08-AFC-13

DOCKET NO. 08-AFC-13

COMMENTS BY
Basin and Range Watch

April 21, 2010

VISUAL RESOURCES - FIGURE 3
Calico Solar Project - Project Viewshed

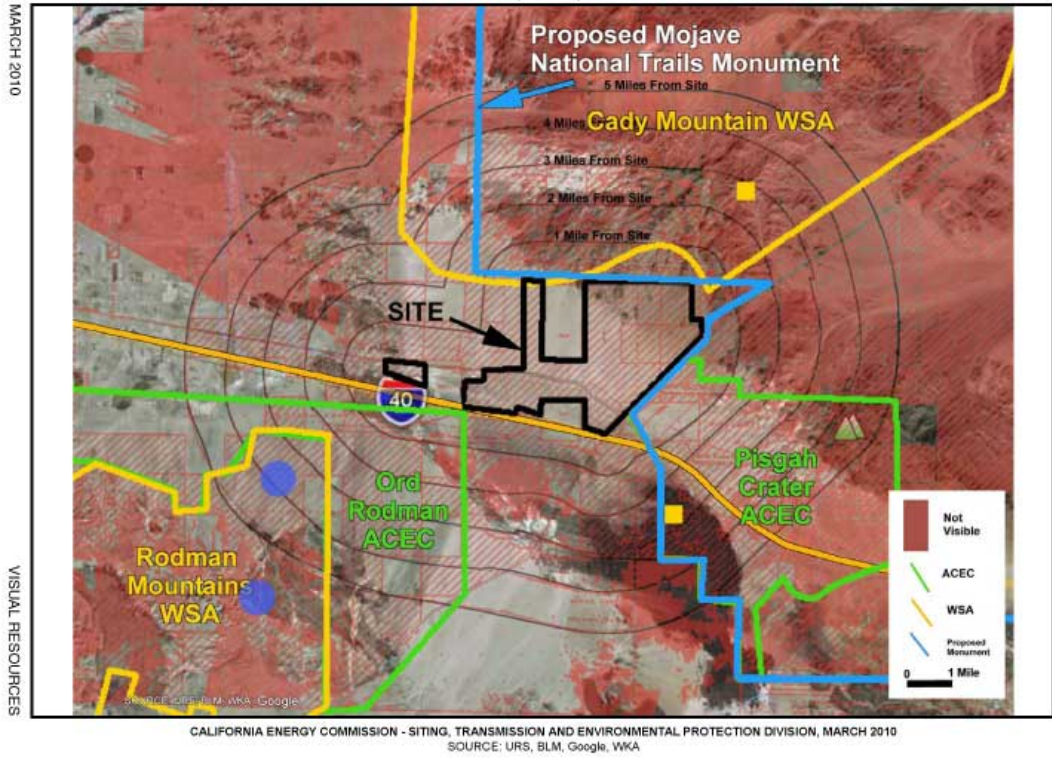
Following participation in the April 16, 2010 Workshop in Barstow, Basin and Range Watch would like to submit suggestions for additional Key Observation Points for Visual Resources analysis. A map is included showing two potential viewpoints from the Rodman Mountains Wilderness southwest of the Project site. The area can be accessed from Interstate 40 by Box Canyon Road.

Map indicating suggested KOP locations in blue, in Rodman Mountains Wilderness.
